<b>NASA Engineering and Safety Center Report</b>	Document #: <b>RP-08-70</b>	Version: 1.0
Title: <b>Ares I-X Vibroacoustic Environments</b>			Page #: 1 of 16

# Ares I-X Vibroacoustic Environments

**June 26, 2008**

**Figure 6.0-1. Vibroacoustic Qualification Flowchart**

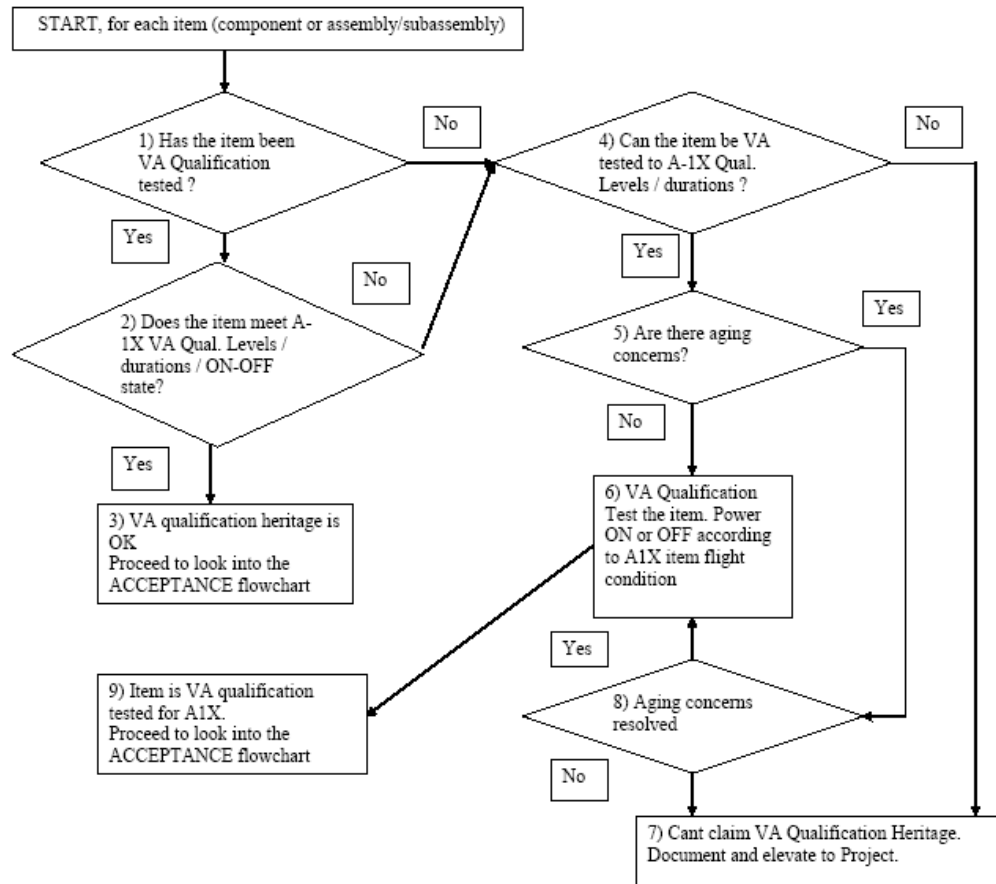
A recommended decision process flow for considering RoCS VA Qualification is provided in Figure 6.0-1, and a similar decision process for Acceptance is provided in Figure 6.0-2. Tables 6.0-1 and 6.0-2, respectively, provide more detailed commentary for each flowchart block item.

Block #	Qualification Flowchart Description
1	The data should include the item qualification random vibration test report and/or acoustic test report. Input for test specifications, tolerances, actual input test data, pre- and post-functional and structural integrity checks data is desired.
2	To compare heritage and A-1X qualification specification test magnitudes, durations, axes of exposure and power status during vibration (ON or OFF).
3	The item is declared “VA heritage qualified”. Now proceed to the acceptance flowchart.
4	Feasibility to include item configuration, facility capabilities.
5	Related to failure modes that could originate due to aging. For example material creep, seals / joints aging or degradation and stiffness changes.
6	Qualification to the A-1X VA environment (non flight item).
7	Qualification heritage cannot be claimed from the VA perspective. The item VA evaluation has to be elevated to the Project for acceptance under a different justification (waiver) or rejection.

8	For example replacing a seal or a G10 washer.
9	Similar to Block #3.

**Figure 6.0-2. Vibroacoustic Acceptance Flowchart**

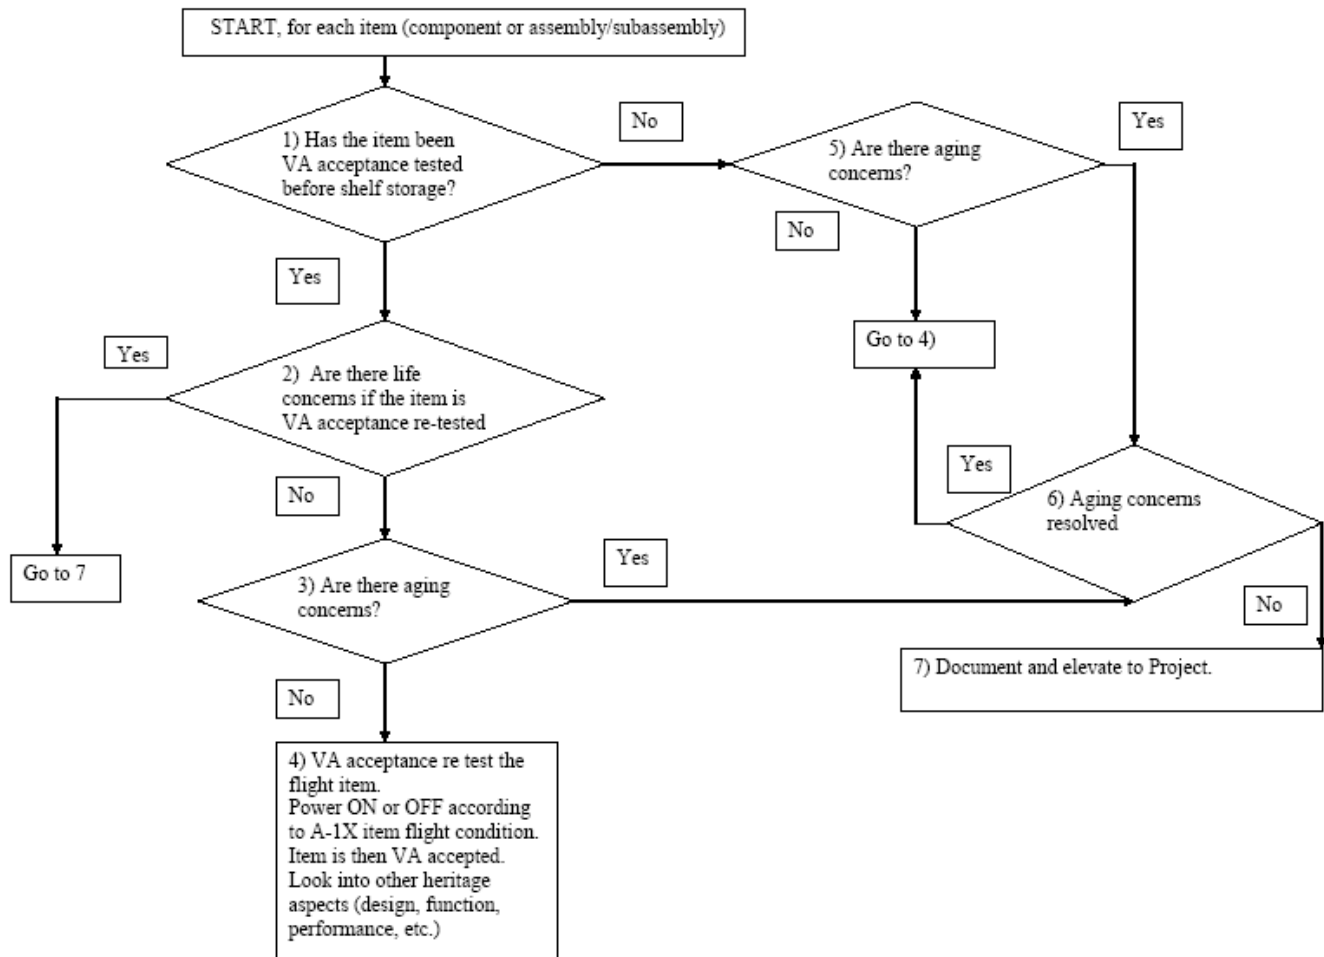
Block #	Acceptance Flowchart Description
1	The data should include the item acceptance random vibration test report and/or acoustic test report. Input for test specifications, tolerances, actual input test data, pre- and post- functional and structural integrity checks data is desired.
2	If the item is to be re-tested for acceptance or re-work, is there remaining life margin available?
3	Related to failure modes that could originate due to aging. For example material creep, seals / joints aging or degradation and stiffness changes.
4	Actual flight item acceptance re-test.
5	Similar to Block #3.
6	For example replacing a seal or a G10 washer.
7	<p>Acceptance recommendation was not implemented. Project to decide accepting the item with other justification (waiver) or rejection.</p> <p>The proto-flight approach (at the item level or its next level of assembly deferring risk) would still be considered a valid approach to accept the flight item if it has not been heritage-qualified or acceptance-tested before. This is the standard philosophy for Payloads.</p>
